CITY OF HENDERSONVILLE
PLANNING BOARD - REGULAR MEETING
Operations Center|Assembly Room|305 Williams St.| Hendersonville NC 28792
Thursday, June 11, 2026 – 4:00 PM

AGENDA

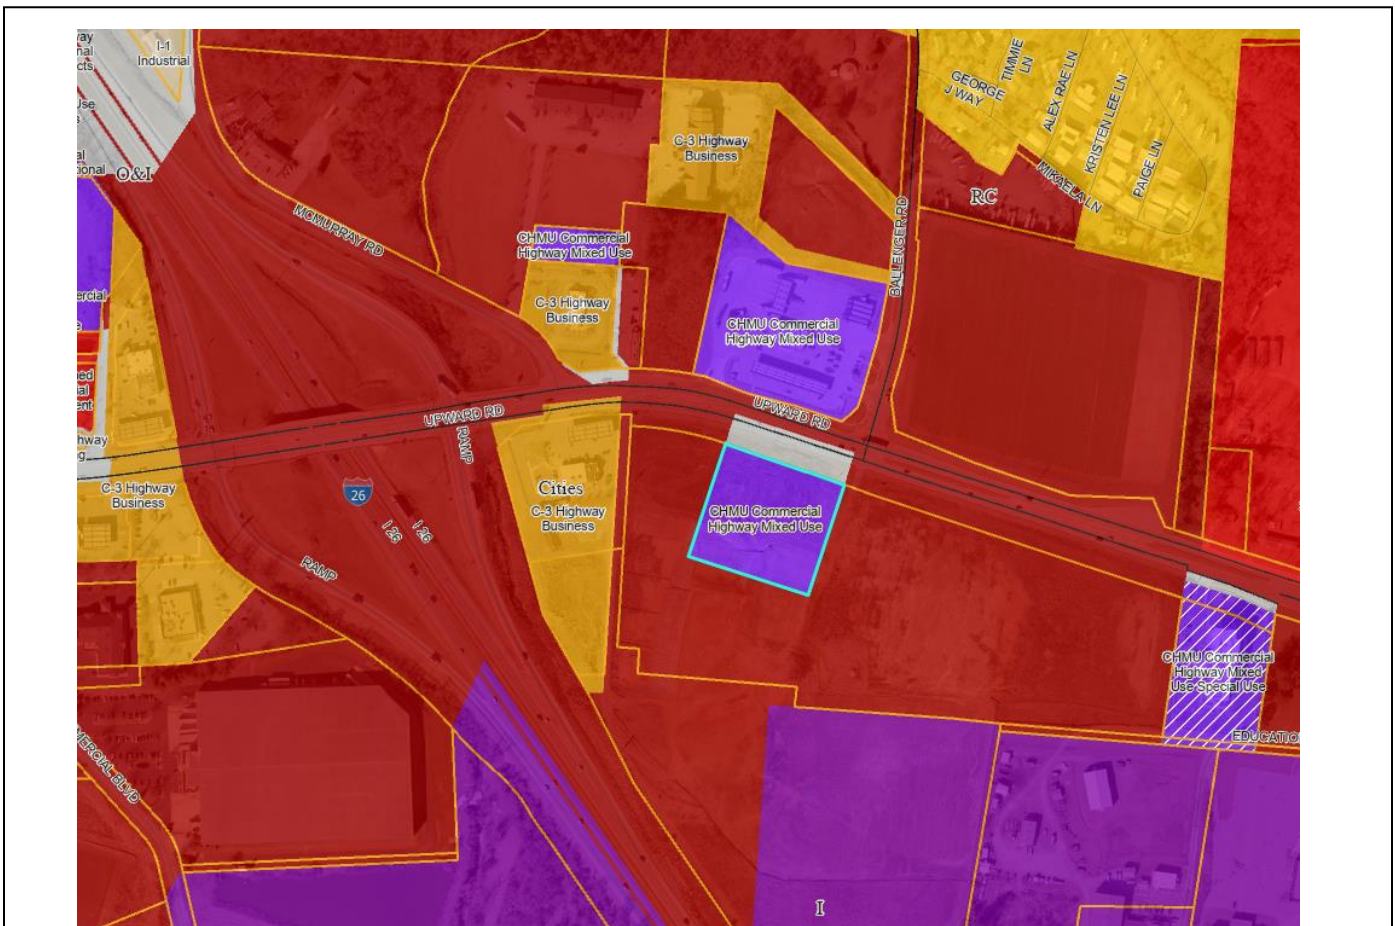
Preliminary plan review is required of all development undergoing Site Plan Review for the following:
